# Access Compliance Report

## Public Rights-of-Way

### (Curb Ramps)

Intersection ID: 47415	Main Street: BRECKFIELD_CT	Cross Street: KIRKWYND_COMMONS_DR	Location: NE
ADA ID: E669660C9198	Ramp Type: BlendTrans1	Initial Pass/Fail: Fail	Overall Compliance: No
Severity Score: 8.75			
Codes/Mitigation Info/Possible Solution		Field Measurements/Component Compliance

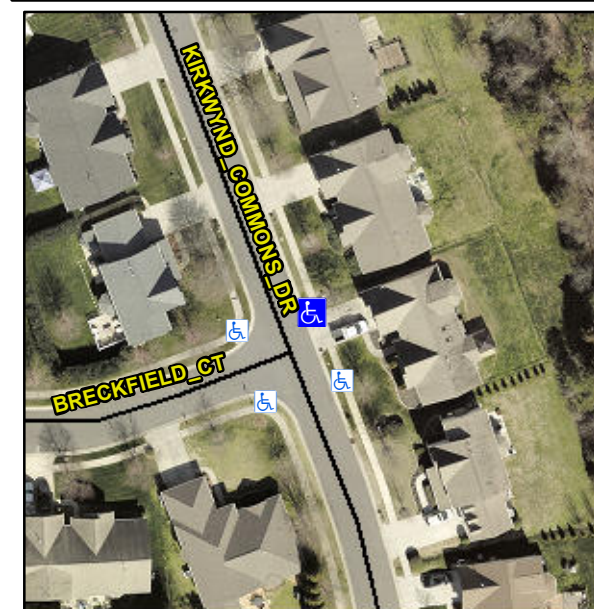
**R304.5.1**

**Remove & Replace Curb Ramp With Two New Directional Ramps or Equivalent.**
